Docket Nos. 50-280 ✓
and 50-281

Change No. 4
License No. DPR-32

UPPER PRESSURIZATION LIMITS
FOR HEATUP AND COOLDOWN
SURRY UNITS NO. 1 AND 2

TS Figure 3.1-1
1-17-73

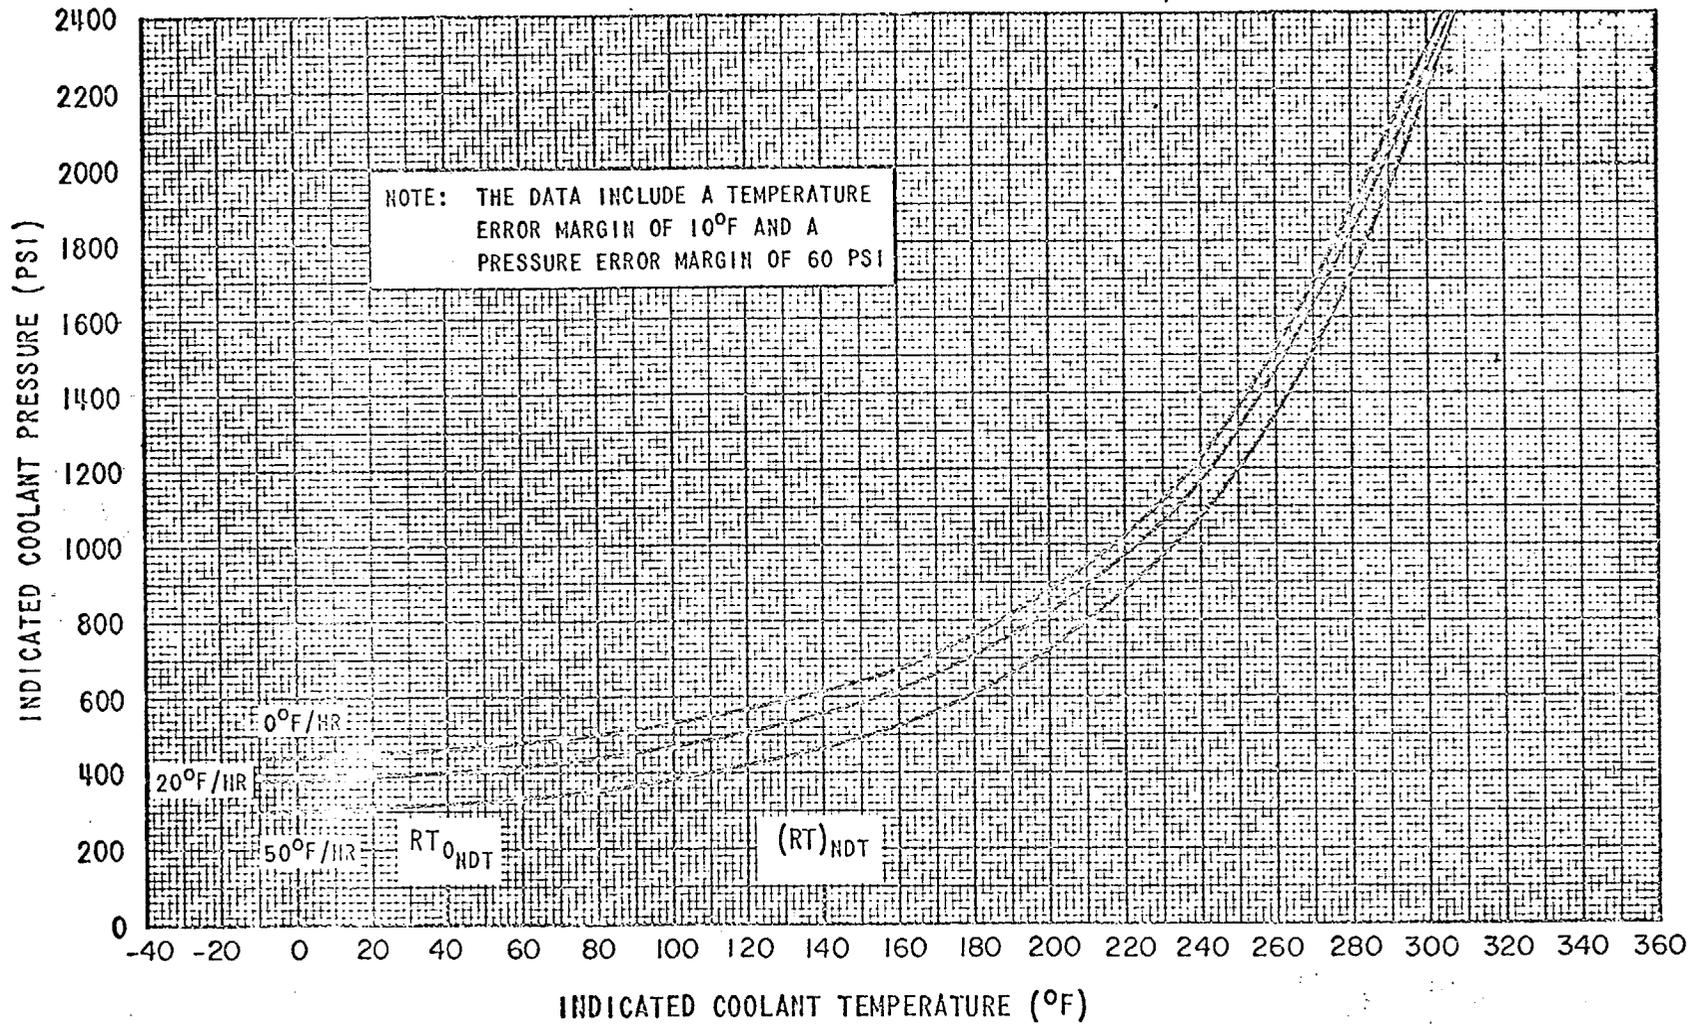
1. Change Technical Specification 3.1.B.1 page TS 3.1-6 (first paragraph) to read, "Unit 1 and Unit 2 reactor coolant temperature and pressure and the system heatup and cool-down (with the exception of the pressurizer) shall be limited in accordance with TS Figure 3.1-1".
2. Change Technical Specification Figure 3.1-1 entitled "Upper Pressurization Limits for Heatup and Cooldown - Surry Unit One" to read "Upper Pressurization Limits for Heatup and Cooldown - Surry Units No. 1 and 2".
3. Change Technical Specification 4.1 by redesignating Table 4.1-3, page TS 4.1-11, entitled "Minimum Frequencies for Flushing Sensitized Pipe" to Table 4.1-3A - Unit No. 1.

1. Unit 1 and Unit 2 reactor coolant temperature and pressure and the system heatup and cooldown (with the exception of the pressurizer) shall be limited in accordance with TS Figure 3.1-1. 4

The 0°F/hr. curve of Figure 3.1-1 may be used for heatup rates of up to 60°F/hr. below an indicated temperature of 304°F and 100°F/hr. above 304°F.

Allowable combinations of pressure and temperature for a specific cooldown rate are below and to the right of the limit lines for that rate as shown in TS Figure 3.1-1. This rate shall not exceed 50°F/hr. for temperatures at or below an indicated temperature of 308°F. For temperatures above an indicated temperature of 308°F, the rate shall not exceed 100°F/hr. The limit lines for rates between those shown in TS Figure 3.1-1 may be obtained by interpolation.

Figure 3.1-1 Upper pressurization limit for heatup is depicted by "0°F/Hour" curve. Upper pressurization limits for cooldown are dependent as depicted, on the cooldown rates. This figure is applicable through an nvt of 1.1×10^{18} neutrons per cm^2 ($E > 1$ Mev)
